Access Compliance Report

Public Rights-of-Way

Intersection ID: 28270	Main Street: PEMSWOOD_ST	Cross Street: SUMMER CLUB_RD	Location: NW
ADA ID: DC79E2E80B90	Ramp Type: Perp	Initial Pass/Fail: Fail	Overall Compliance: No
Severity Score: 25			
Codes/Mitigation Info/Possible Solution		Field Measurements/Component Compliance

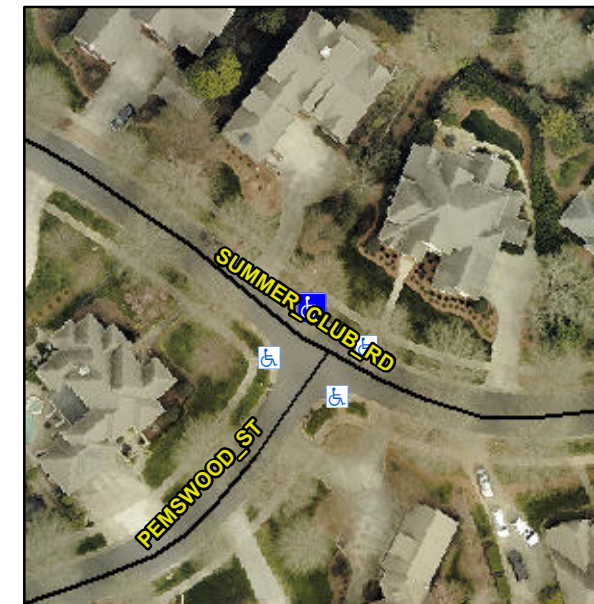
R304.2.2, R304.5.3

Compliance	Description	Data	Compliance	Description	Data
N/A	Ramp Length (in)	93.0	No	Ramp Slope (%)	9.8
Yes	Ramp Width (in)	53.0	No	Ramp XSlope (%)	5.5
N/A	Flare Type LT	N/A	N/A	Flare Type RT	N/A
N/A	Flare Slope LT (%)	N/A	N/A	Flare Slope RT (%)	N/A
N/A	Flare Traversable LT?	N/A	N/A	Flare Traversable RT?	N/A
N/A	Landing Length (in)	N/A	N/A	DWS Provided?	N/A
N/A	Landing Width (in)	N/A	N/A	DWS Contrast?	N/A
N/A	Landing Slope (%)	N/A	N/A	DWS Length (in)	N/A
N/A	Landing X Slope (%)	N/A	N/A	DWS Full Width?	N/A
N/A	Landing Curb? (Y/N)	N/A	N/A	DWS Offset (in)	N/A
N/A	Shared Landing?	N/A			
N/A	Gutter Ponding?	N/A	N/A	Gutter Slope (%)	N/A
N/A	Gutter Lip Ht (in)	N/A	N/A	Gutter X Slope (%)	N/A
N/A	Painted X Walk1?	No	N/A	Painted X Walk2?	N/A
	X Walk 1 Direction	To SW		X Walk 2 Direction	N/A
N/A	X Walk 1 Width (in)	N/A	N/A	X Walk 2 Width (in)	N/A
	X Walk 1 Slope (%)	0.8		X Walk 2 Slope (%)	N/A
	X Walk 1 X Slope (%)	1.2		X Walk 2 X Slope (%)	N/A

Remove & Replace Entire Ramp.
